Groundwater Transfer Review Summary Form

Transfer/PA # T- 13804

Application: T-13804

Applicant Name: Eileen M Clark Living Trust

T-13804 Eileen Clark Living Trust

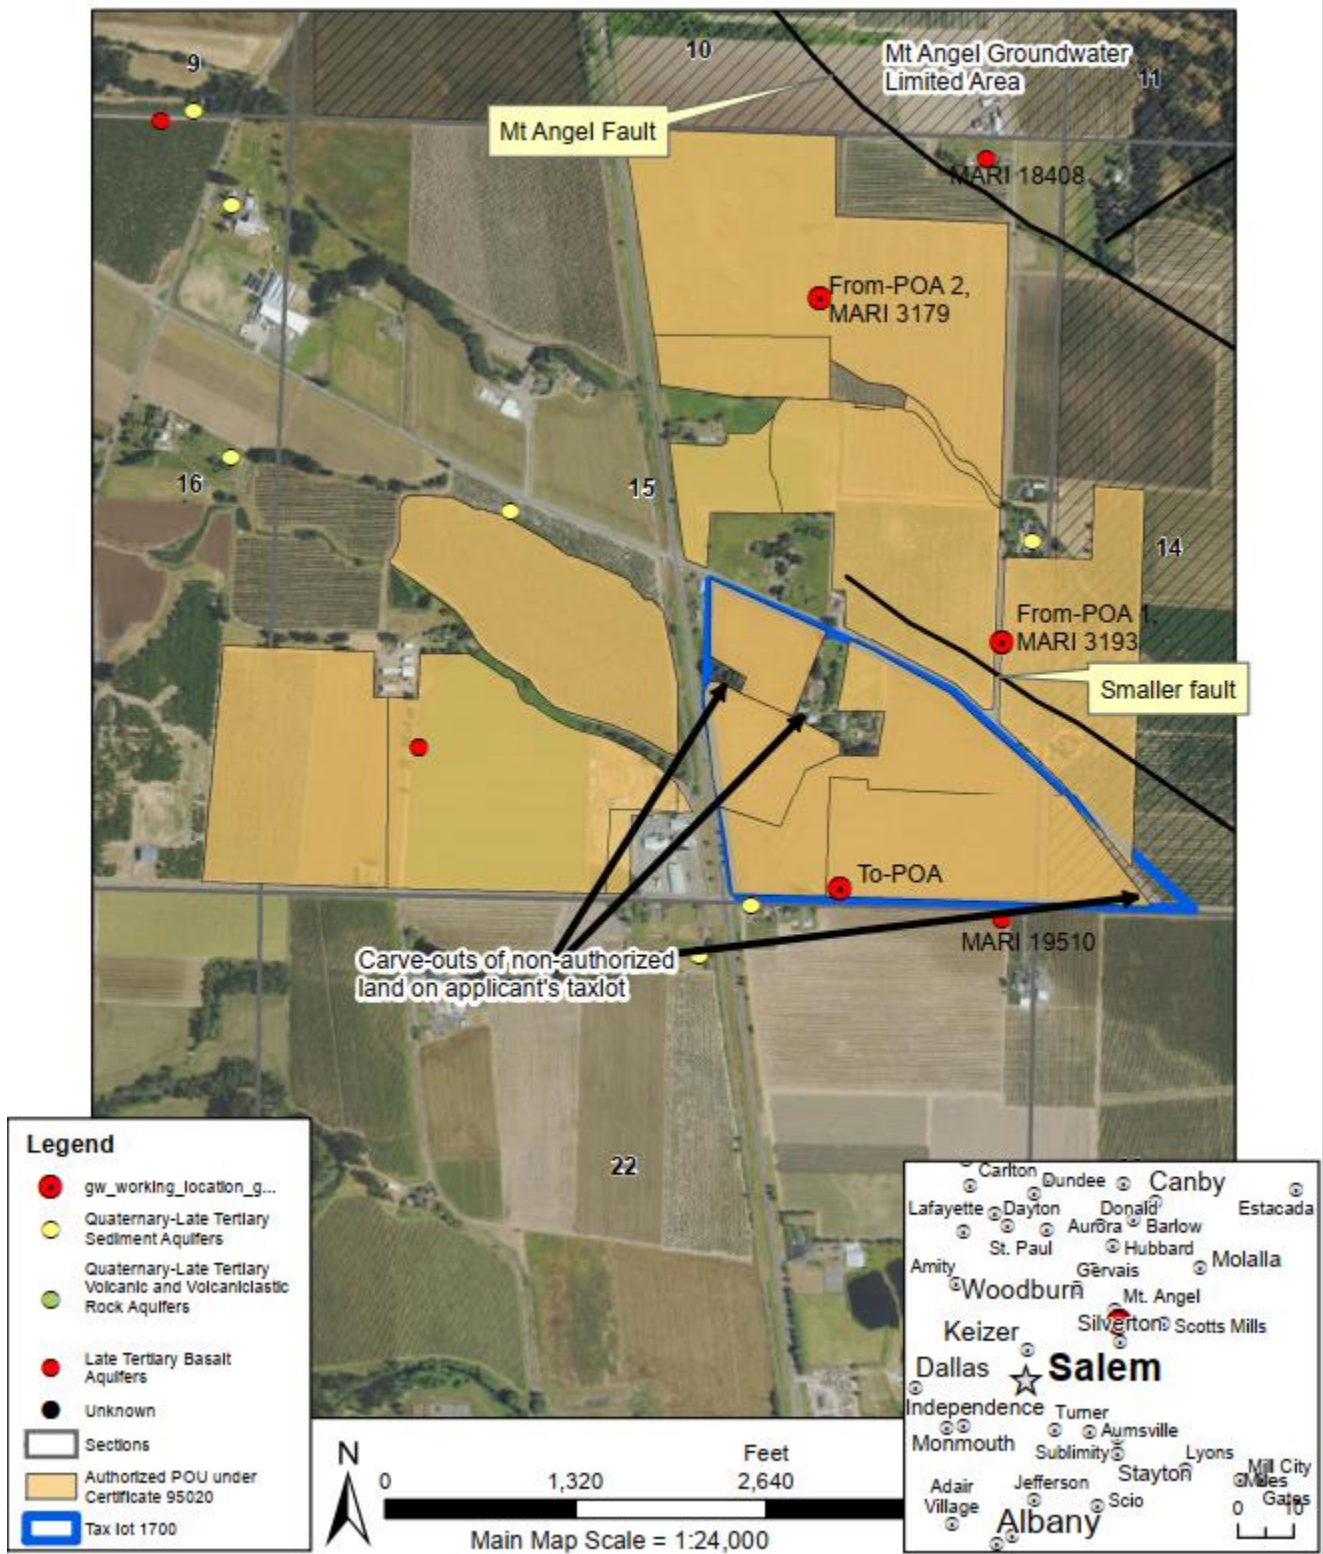
The applicant's map does not appear to accurately depict the authorized POU vs non-authorized land on tax lot 1700. There are 3 'carve-outs' not authorized, and the applicant's map is not of sufficient detail to confirm that the carve-out on the east side of their tax lot is incorporated. It is assumed that this is an error in the applicant's map, and that a POU transfer is not included with this application.

Interference proposed To-POA with MARI 19510

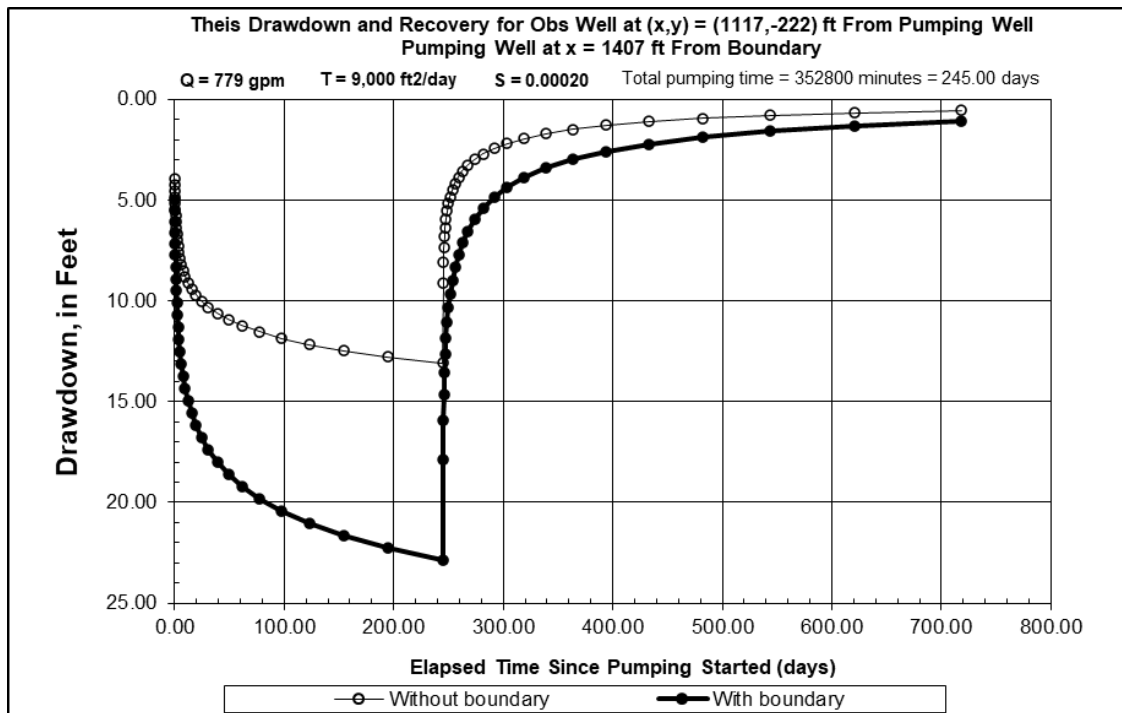
☐ Yes ☒ No If yes, explain: The potential for Substantial or Undue Interference (SUI) per OAR 690-008-0001(8)(c) with MARI 19510 due to the proposed change was assessed using the Theis (1935) solution for drawdown in a confined aquifer assuming the fault to the northeast of the proposed To-POA and MARI 19510 acts as a no-flow boundary (hydraulic barrier). Results of this analysis indicate that the anticipated change in well-to-well interference at MARI 19510 due to the proposed change will increase, with interference from the proposed To-POA exceeding 15 ft within 2 weeks and a maximum of 23 ft (see Theis Drawdown Analysis, attached). In aquifers where permeability is not relatively uniform, full penetration may not be required; therefore, interference with MARI 19510 cannot be discarded based on its construction not penetrating the full depth of the CRBG. Pumping at the rate identified in this review (1.736 cfs) at the proposed To-POA is not anticipated to result in MARI 19510 not receiving the water to which it is legally entitled.

- Transmissivity: 9,000 ft²/day [median for nearby pumping tests]
- Storativity of Aquifer: 0.0002 [Conlon et al., 2005]
- Total Pumping Time: 245 days [irrigation season, March 1 through October 31]
- Pumping Rate: 1.73563 (799 gpm)
- Distance to MARI 19510: 1,117 ft east, 222 ft south
- Distance to No-flow boundary (fault): 1,407 ft east
